REFERENCE:	TSB: 23-046-23 GROUP 23 - Body	Date:	April 25, 2023	REVISION:	-
VEHICLES AFFECTED:	2022 (WS) Grand Wagoneer/Wagoneer This bulletin applies to vehicles built on or after August 01, 2022 (MDH 0801XX) and on or before November 29, 2022 (MDH 1129XX).	MARKET APPLICABILITY:			
CUSTOMER SYMPTOM:	<p>Customers may experience one or more of the following:</p> <ul style="list-style-type: none"> Fuel door won't open or is stuck closed. Tabs holding the actuator which provide the push to open function on the fuel door have broken (Fig. 1) . 				
CAUSE:	Design issue.

Fig. 1
Fuel Filler Door Housings

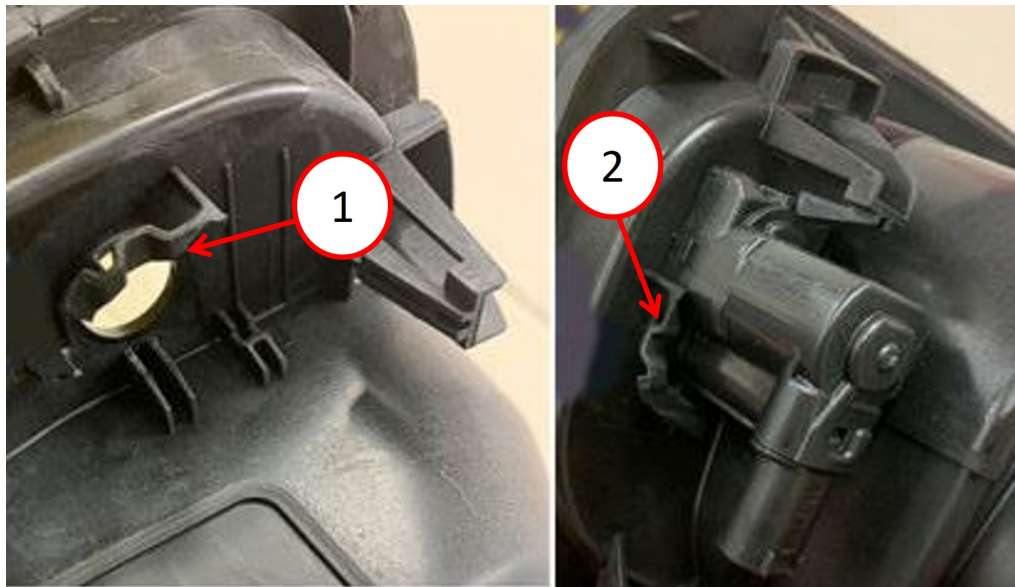
- 1 - Broken Housing Tabs NOT Holding Actuator
- 2 - Housing Tabs Holding Actuator

This bulletin involves replacing the fuel filler door housing.

1. Replace the fuel filler door housing. Refer to the detailed service procedures available in DealerCONNECT> Service Library under: Service Info>23 - Body / Exterior / Housing, Fuel Fill / Removal and Installation.
